DISCUSSION of:

Ground Improvement Using Preloading with Prefabricated Vertical Drains

Full Reference: Dhar, A.S., Siddique, A., Ameen, S.F., (2011). Ground Improvement using Pre-loading with Prefabricated Vertical Drains. International Journal of Geoengineering Case Histories, <http://casehistories.geoengineer.org>, Vol.2, Issue 2, p.86-104. doi: 10.4417/IJGCH-02-02-01.

Bengt H. Fellenius, Dr. Tech., P.Eng., Canada; email: bengt@fellenius.net

Figure 1. Settlement measured at the benchmarks shifted 10 days.

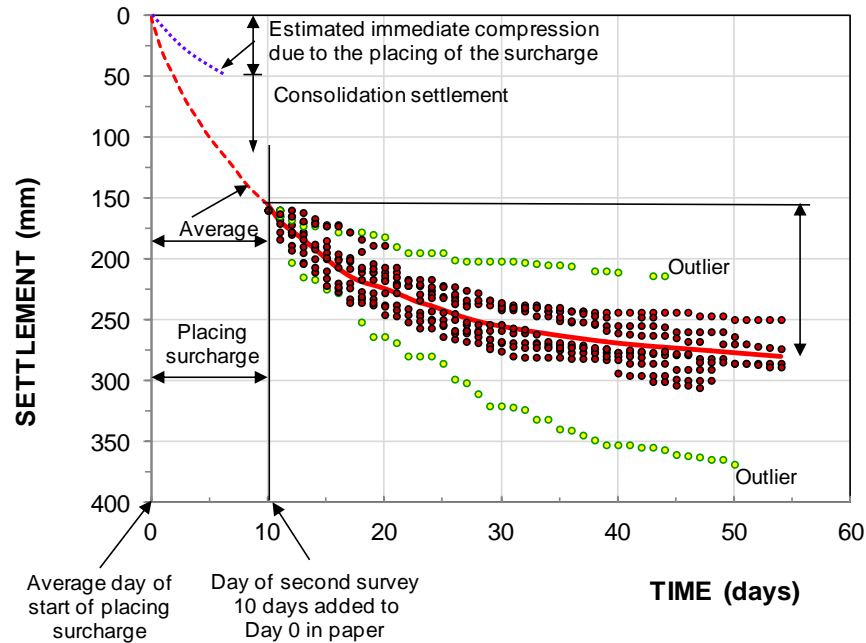
The authors report, that the first survey of the benchmarks was taken before the 3.0-m surcharge was placed across the test area. The first day of settlement measurements for the twelve benchmarks was the date of the second benchmark survey, which was carried out only when all of the surcharge had been placed to the full height over the test area. The time between the first and second surveys—and the placing of the surcharge—ranged from a few days to twenty days. Because the times between the placing of the surcharge and the second survey differed for the benchmarks, the amount of settlement that had occurred at the time of the second survey also differed between the benchmarks. This explains some of the significant scatter displayed in the authors' Figure 13. I have re-plotted the measured settlements in Figure 1 to a common starting point at the average start settlement of 160mm and added 10 days to the authors' measurement days to indicate the average duration of placing the surcharge, which took place before the second survey. During this time, immediate compression and some consolidation will have occurred. As indicated, I estimate the immediate compression to be about 50 mm. I have also added an average curve and extrapolated it back to the origin (the average excludes the two outlier records). All benchmarks appear to show that most of the consolidation had developed at the time the last survey was made.

Figure 2. Settlement measured at the benchmarks normalized to the average end values.

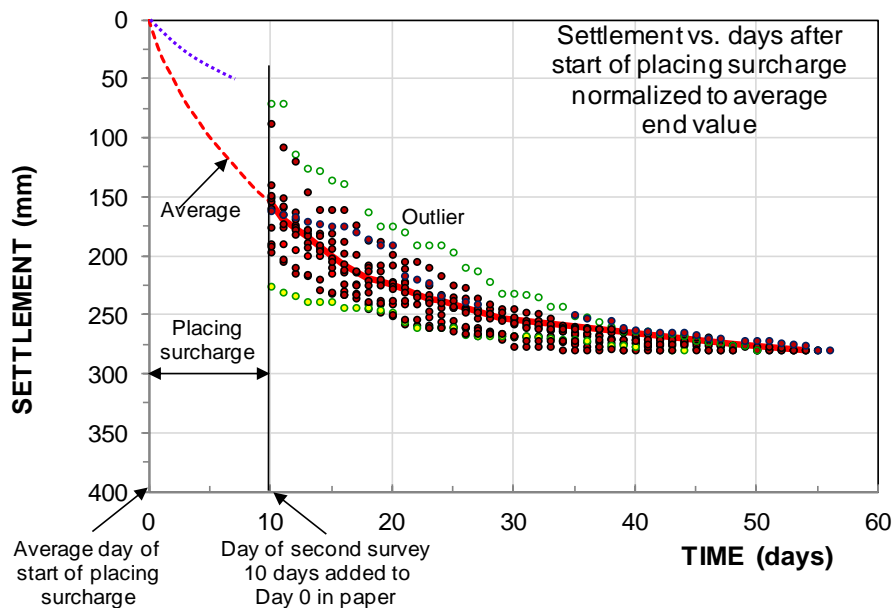
Figure 2 shows the measured final settlements are normalized to the average final settlement (280 mm). There is still much scatter between the curves, but now the approximate start date for each curve can be obtained by sliding the curves left or right until the best agreement to the average curve is obtained as shown in Figure 3. The removal of much of the scatter—the agreement between the time-settlement curves—is of course to some extent fictitious as the benchmark measurements cannot be expected to be all that similar; a natural variation must have taken place, not least with regard to the thickness of the soft clay layer. However, I believe that the figure suggests a reasonably realistic day for the start of placing the surcharge.

Figure 3. Settlement measured at the benchmarks adjusted to obtain the approximate start day.

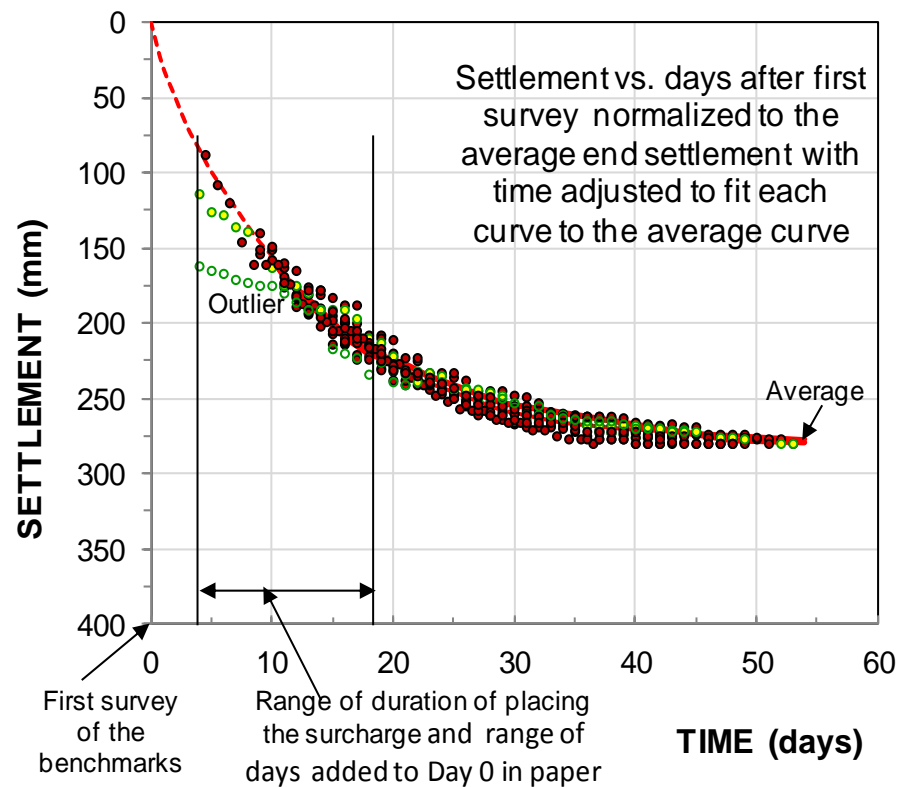
The average curve shown in Figure 3 can now serve as reference to a back-calculation of the time-settlement development for the wick-drain project to determine compressibility and coefficient of consolidation of the soil layers. The back-calculation consists of applying the theory of pore pressure dissipation in fine-grained soils (consolidation) due to radial flow (Barron 1948, Kjellman 1948, and Hansbo 1960; 1979) is based on radial flow toward a circular drain in the center of a cylinder of homogeneous soil with an impervious outer boundary surface). The theory is summarized in the Kjellman-Barron formula, Equation 1. The Kjellman-Barron formula is based on the assumption of horizontal (radial) flow only and a homogeneous soil.

Figure 4. Average measured and calculated settlements.

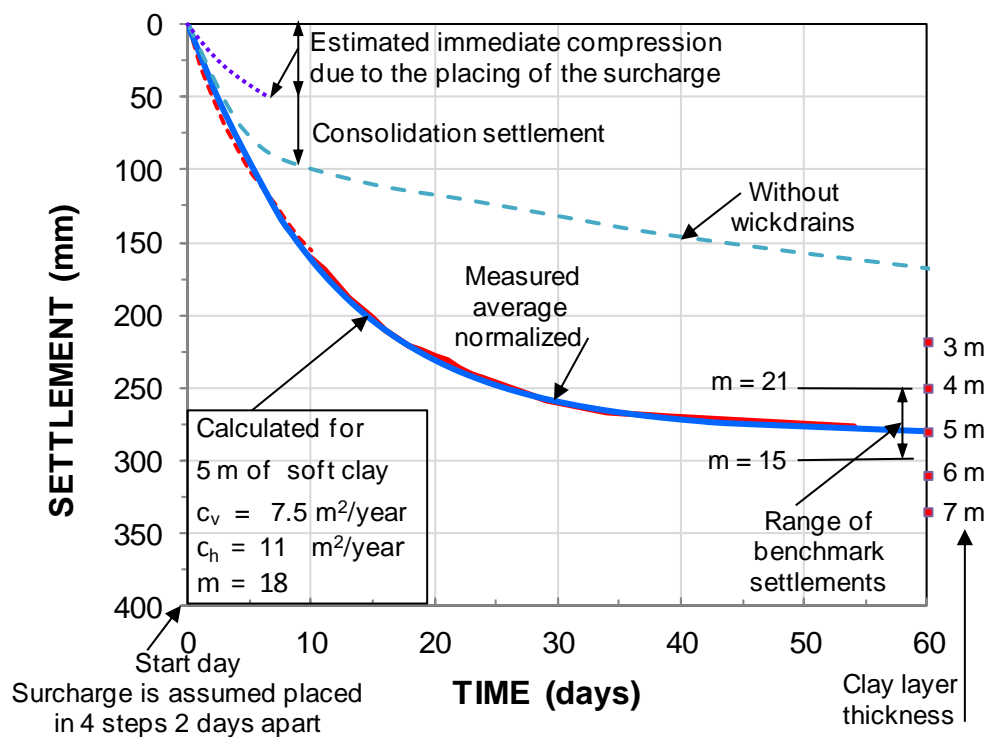
The results of the back calculation are shown in Figure 4 together with the average curve of the measurements. In order to show the sensitivity of the clay layer thickness and modulus number, the figure also shows the final settlement for soil layer thickness ranging from 3 through 7m and the final settlement resulting from modulus numbers of 15 and 21. The figure also shows the settlement during the first 60 days that would have occurred had there been no wick drains (for this input, I used the authors' 7.5 $m^2/year$ c_v -coefficient).

Considering that my data reduction is quite different to that of the authors, my back-calculated c_h -coefficient (11 $m^2/year$) agrees well with the authors' laboratory-established value (14 $m^2/year$). The difference could be taken to represent the effect of a smear zone. However, considering all the uncertainties involved, I believe the agreement to be entirely fortuitous.
